**Drain:** BENTLEY OAKS 24"  
**Improvement:** Bentley Oaks SCL 1  
**Operator:** JIM SNOUFFER / JARED LIVINGSTON  
**Date:** 9-18-03  
**CLASS** URBAN  
**YEAR CONST** 1991 ASB014 ID 114-0450

RE: Bentley Oaks Drain

**Re: Bentley Oaks Drain - Sec. 1 Arm**

**Re: Bentley Oaks Drain: Sec. 1 Arm (Revised Final Report)**

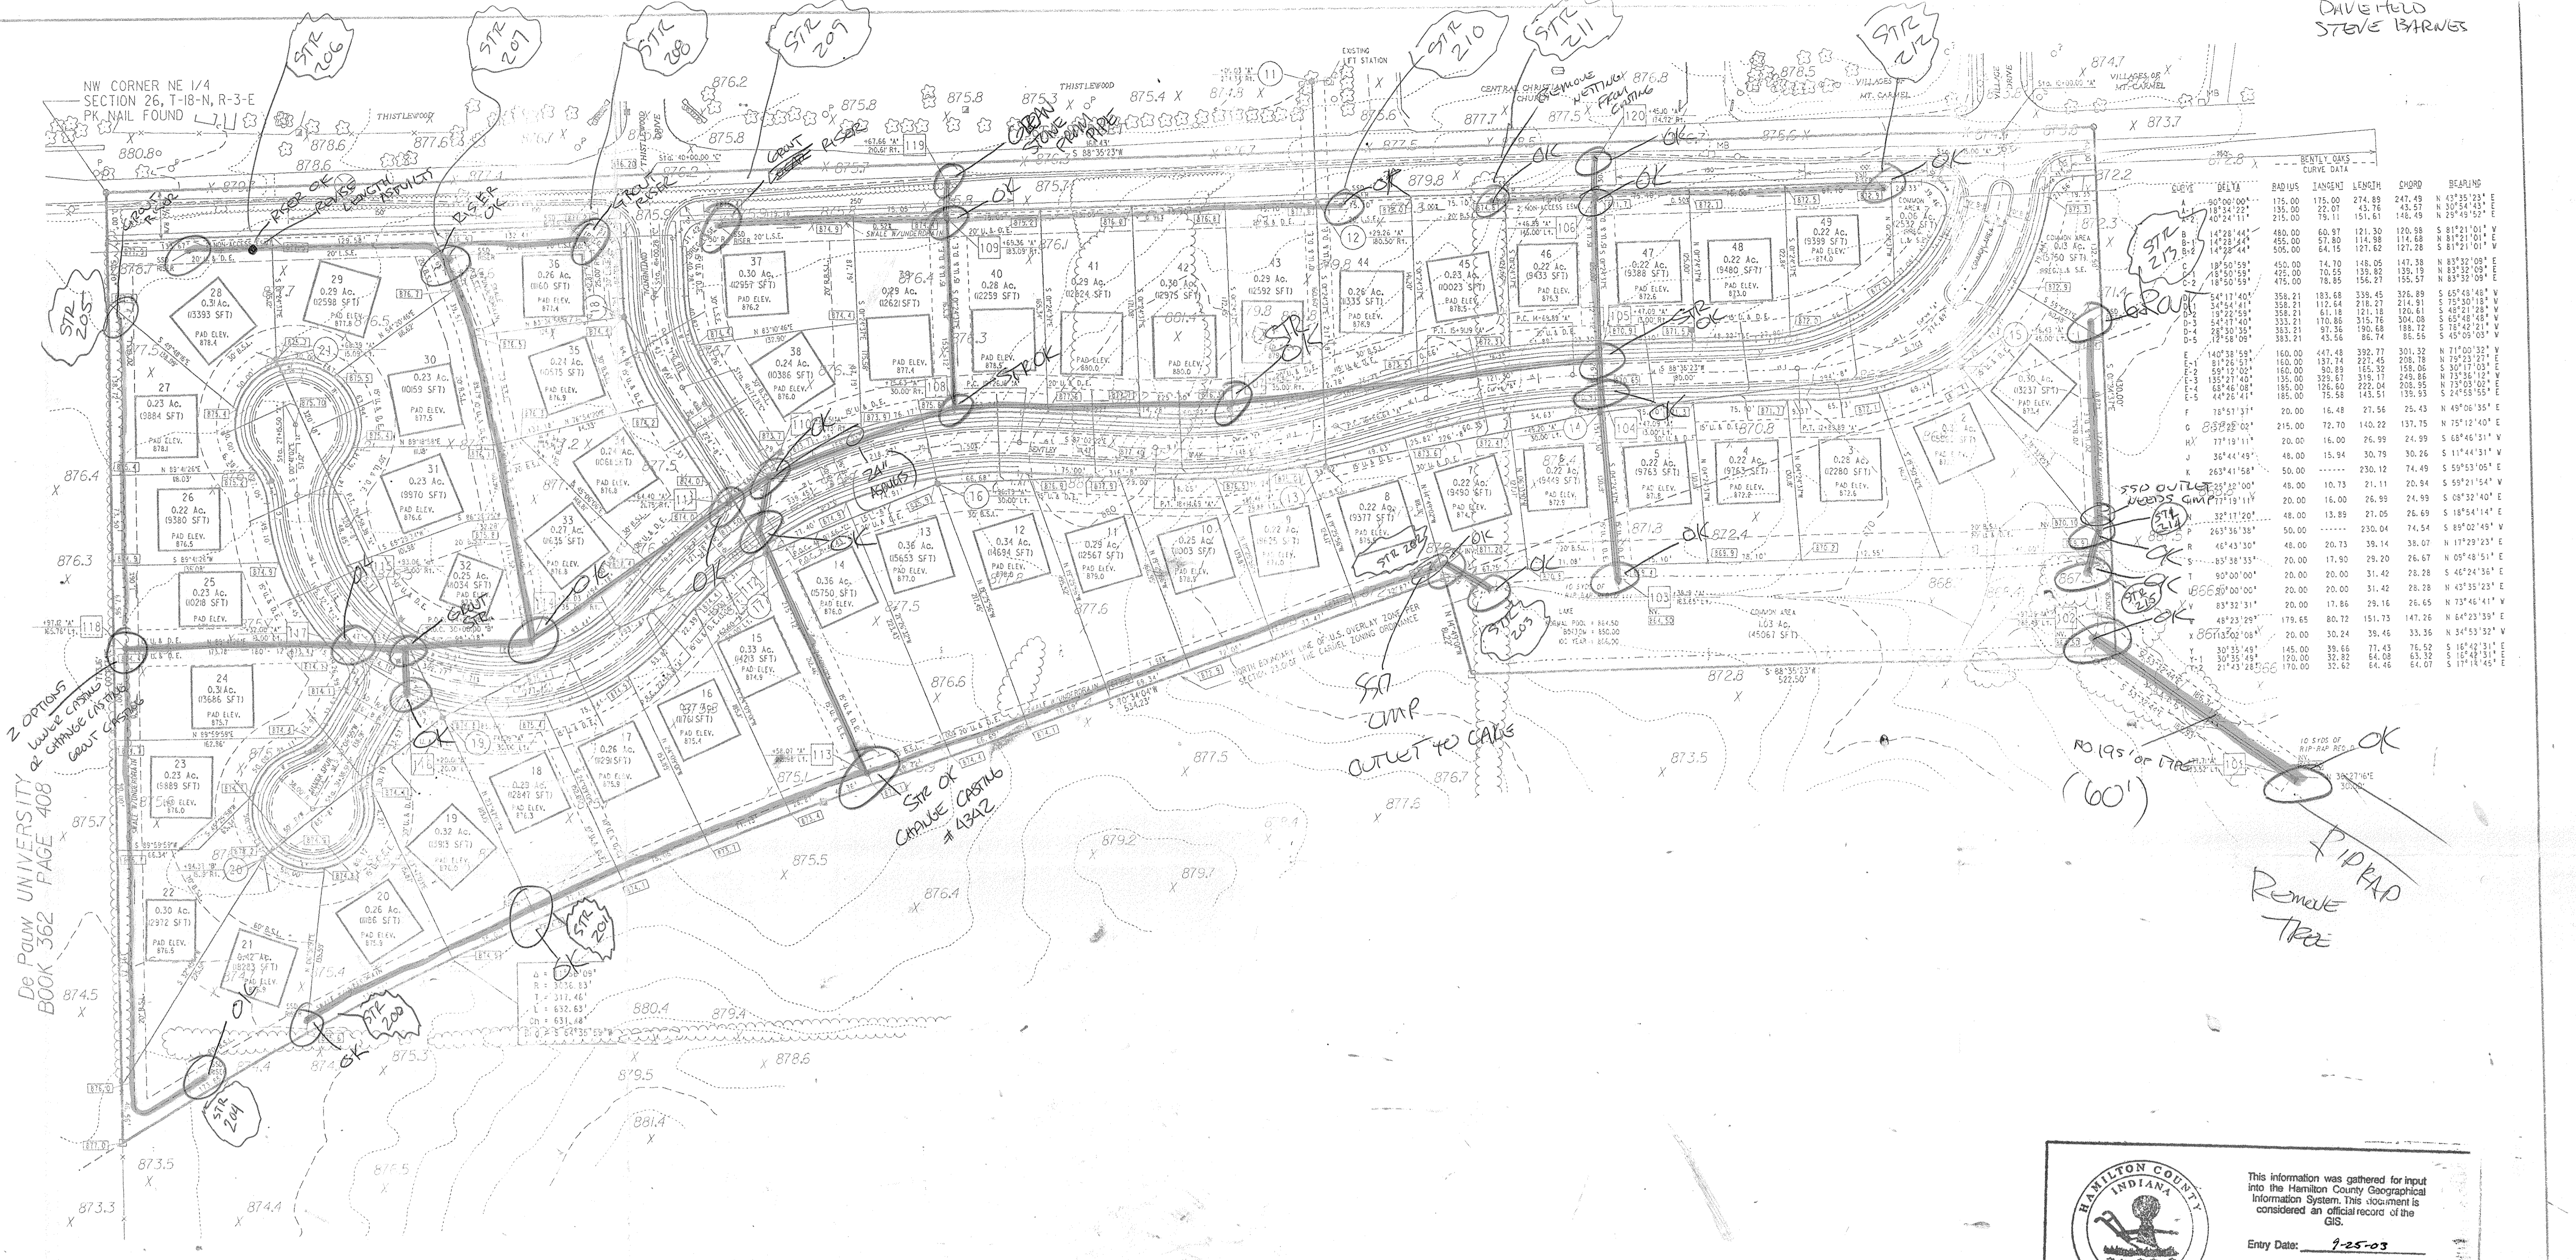
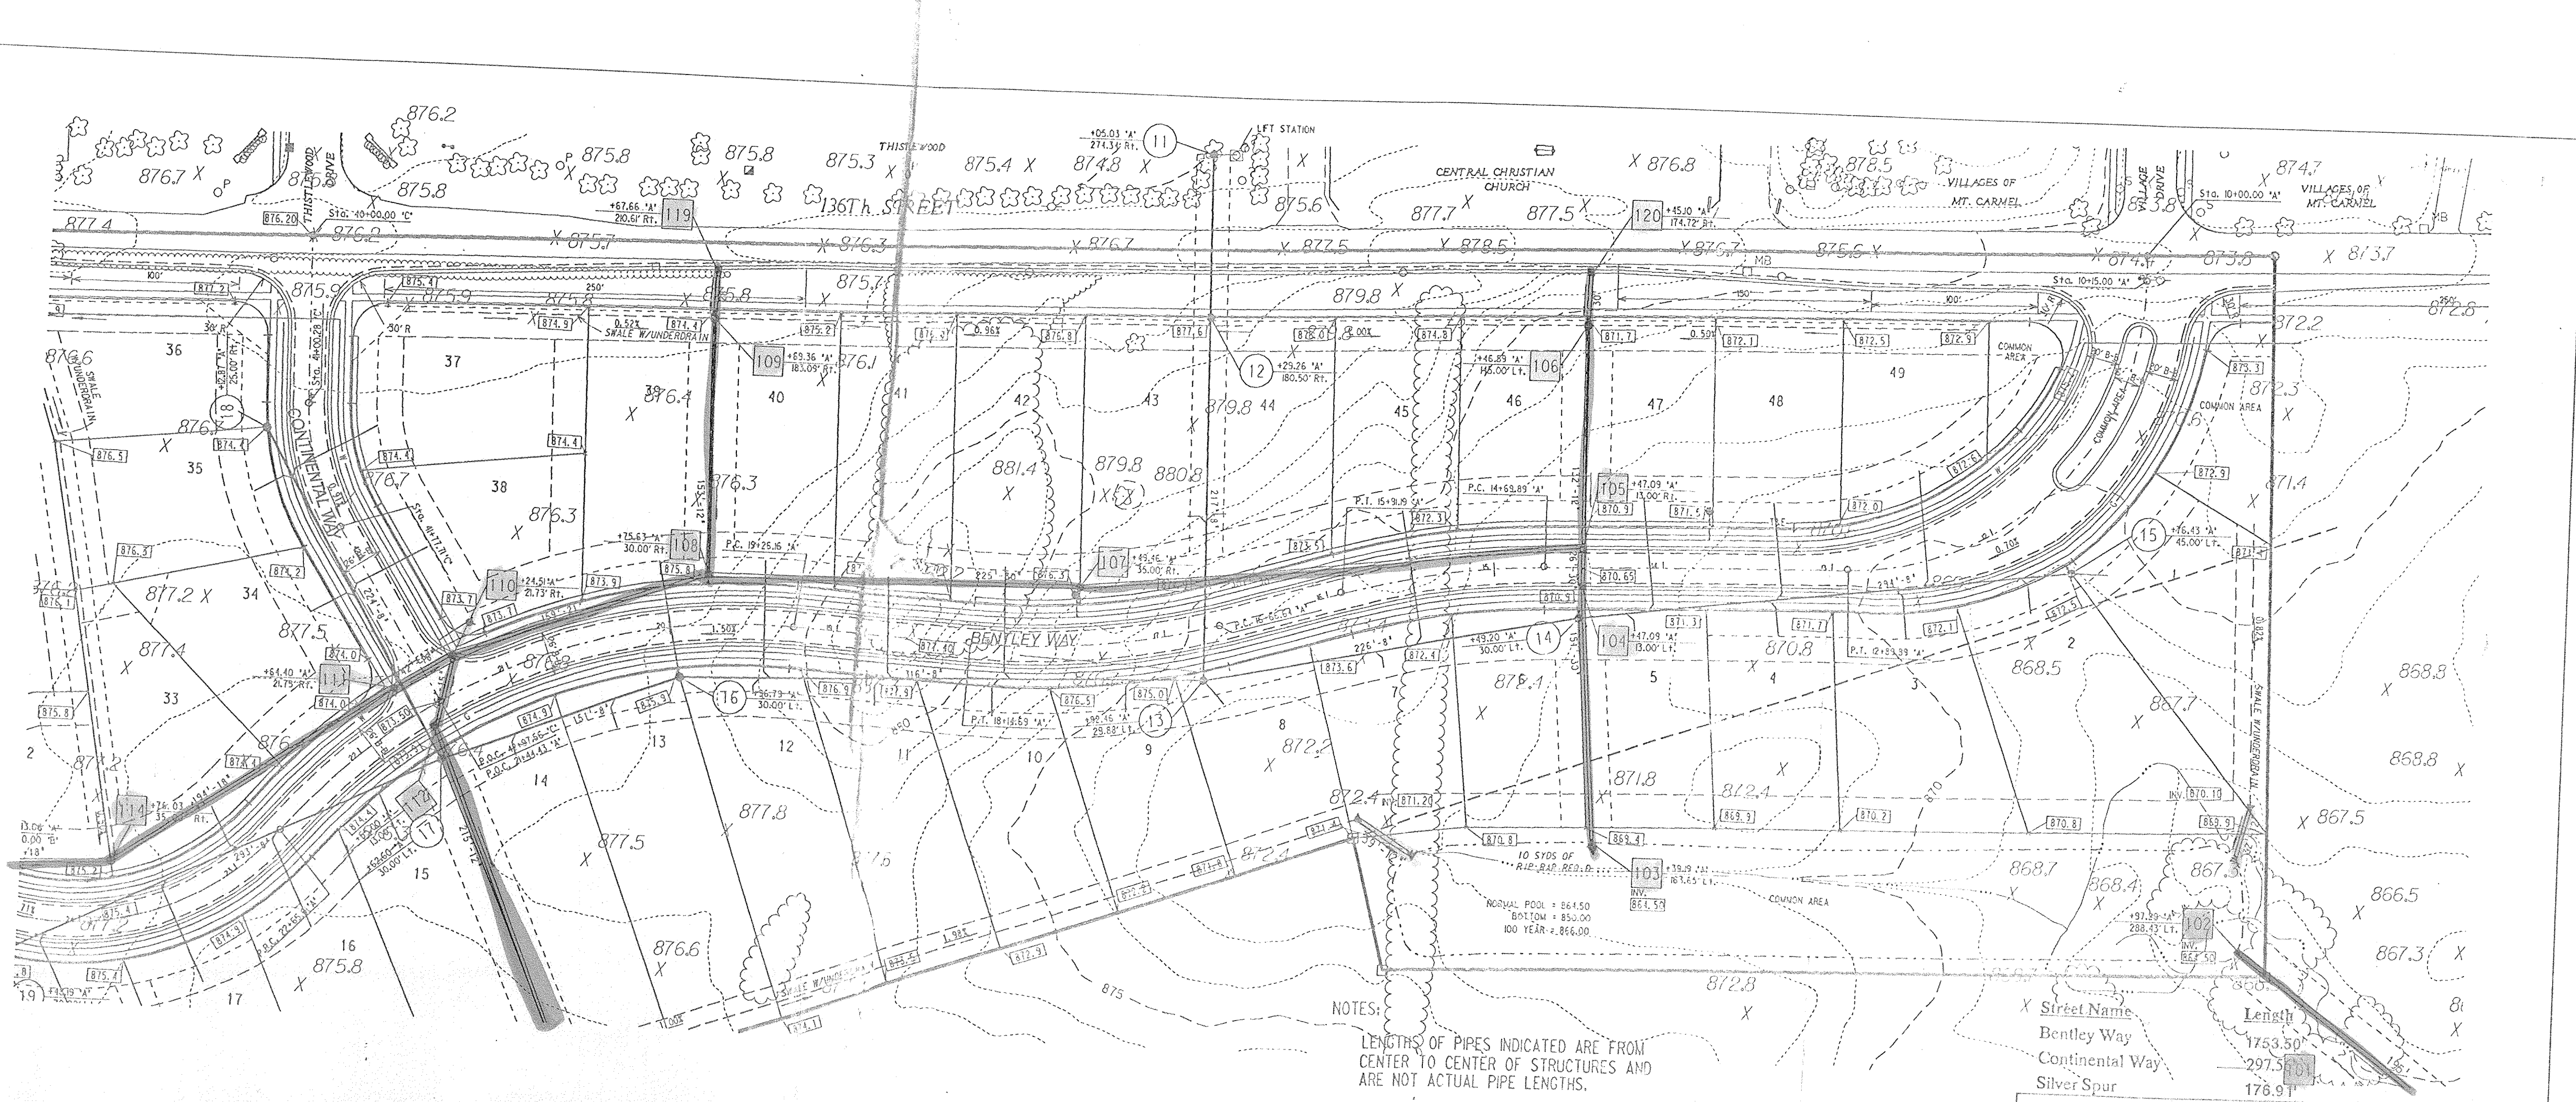
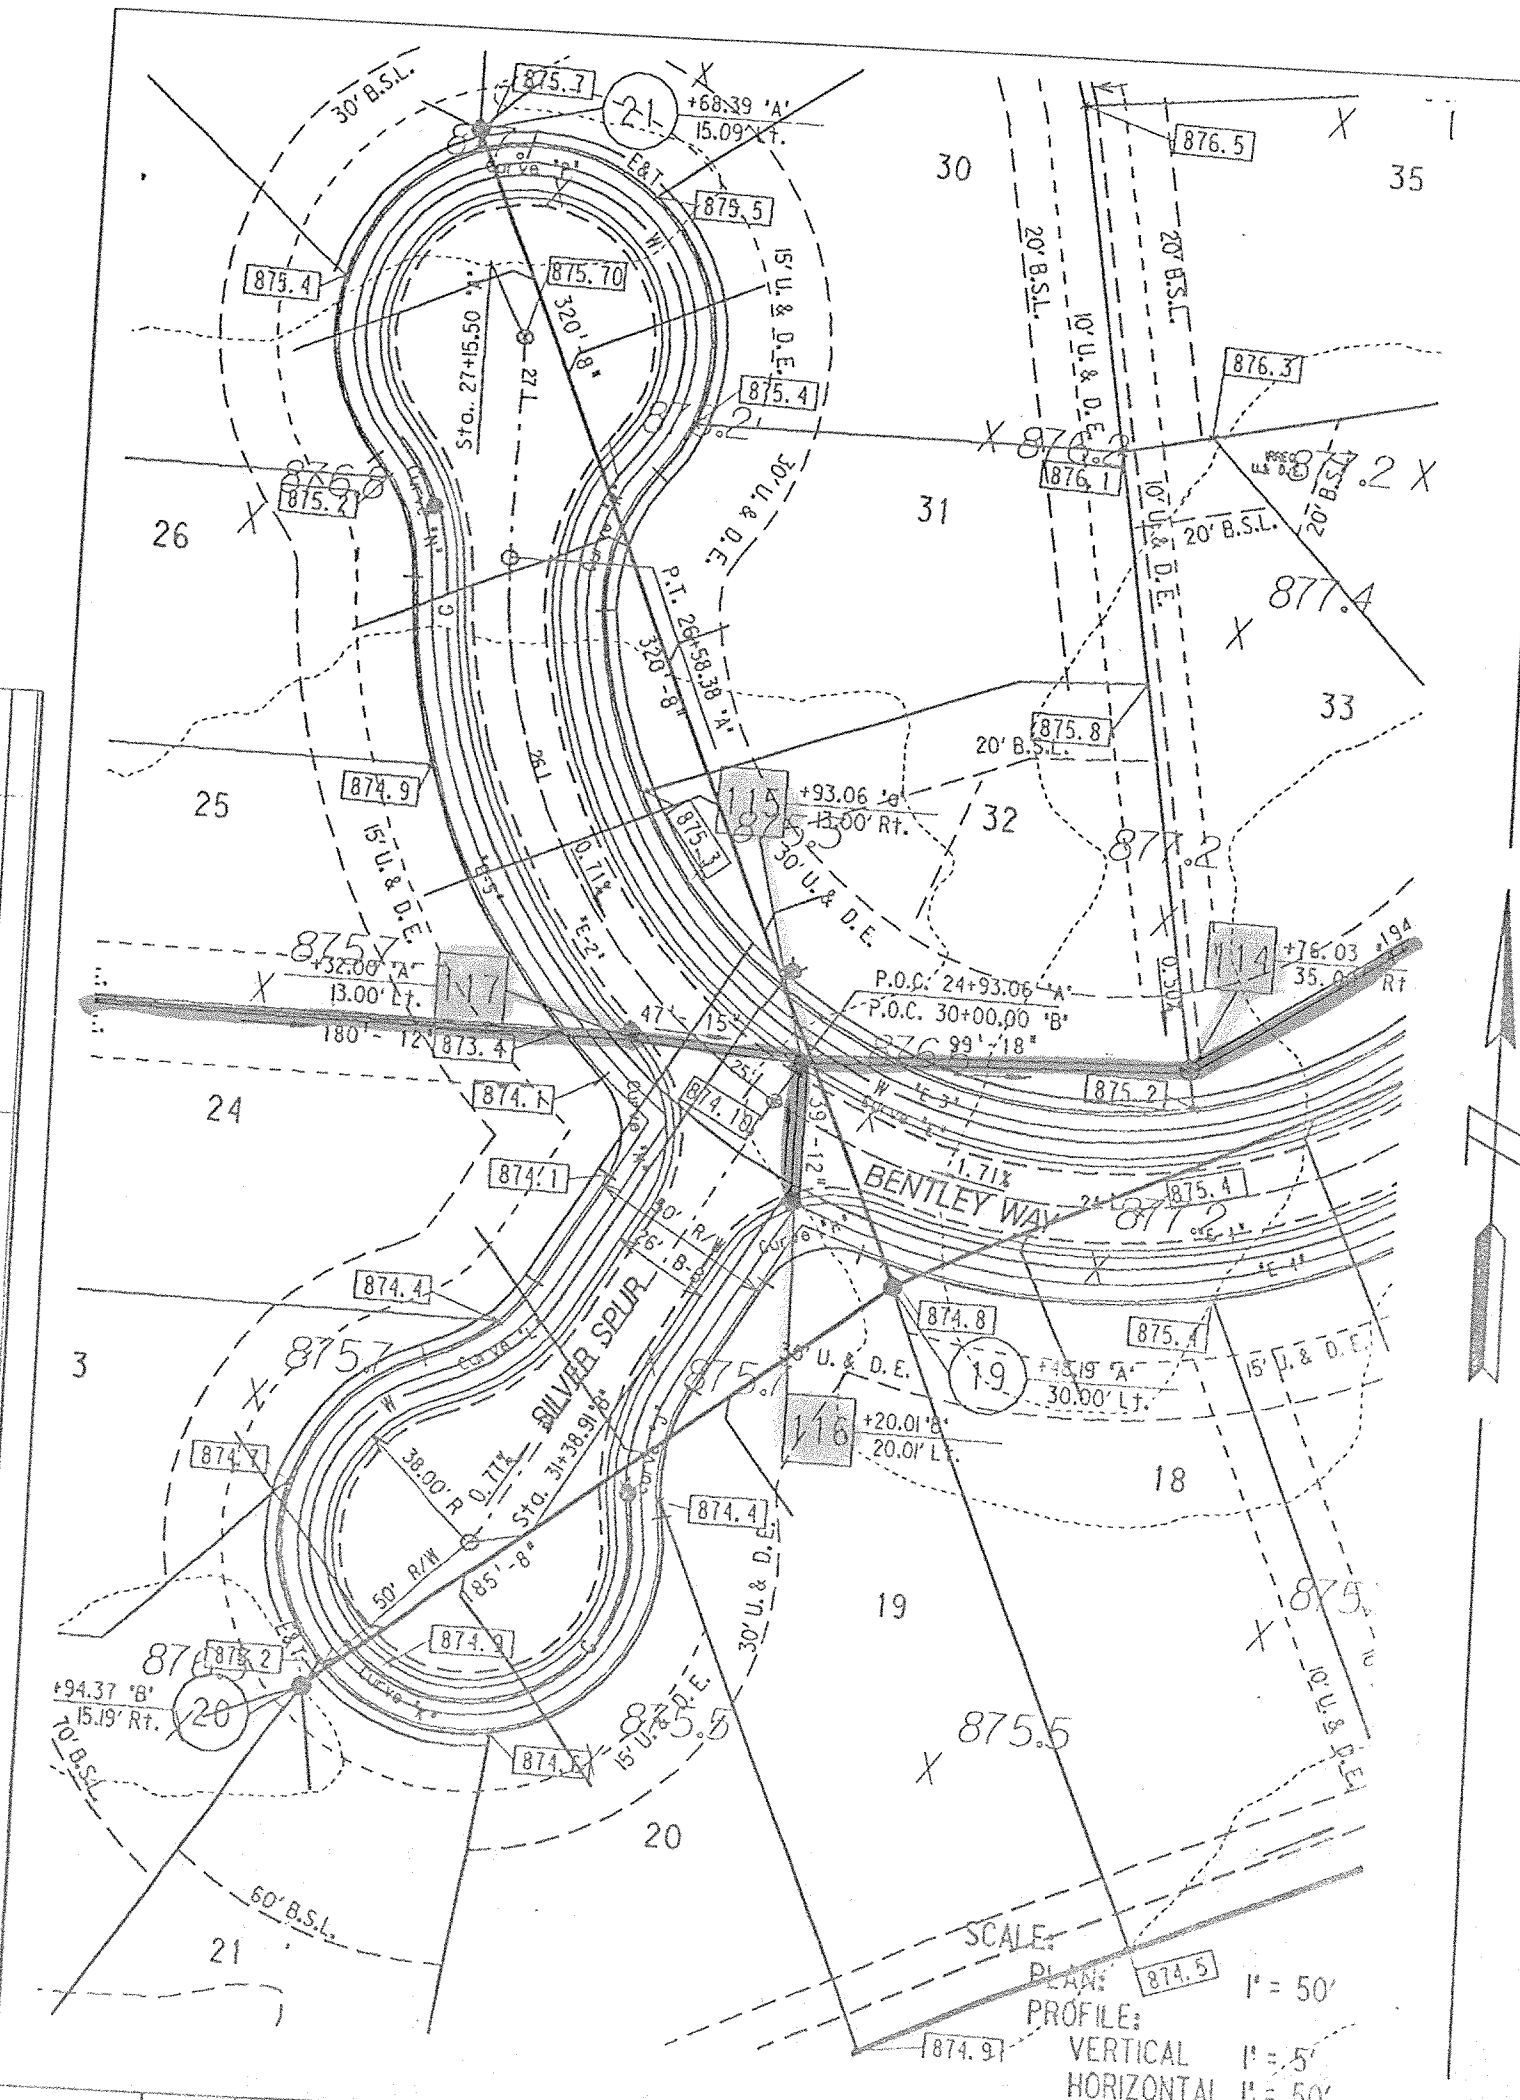
\* Digitize/Rectify 6" SSD ✓

\* STR 102-101 - needs new feature (storm instead of SSD) ✓

\* digitize pond ✓

\* STR 108-110 Label 24" ✓

STR 115-117 Label 12" ✓

STR 107 - needs removed - street pipe from 108-105 31' - 30" RLA ✓

\* digitize SSD under curbs & put lengths for rear yard SSD ✓

During construction, changes were made to the drain which will alter the plans submitted with my report for this drain dated February 11, 1992. The changes are as follows: The 12" RCP is now 872.34' feet. The 15" RCP is now 110.66' feet. The 18" RCP is now 335.89' feet. The 24" RCP is now 159.91' feet. The 30" RCP is now 698.35 feet. Structure 107 was not constructed.
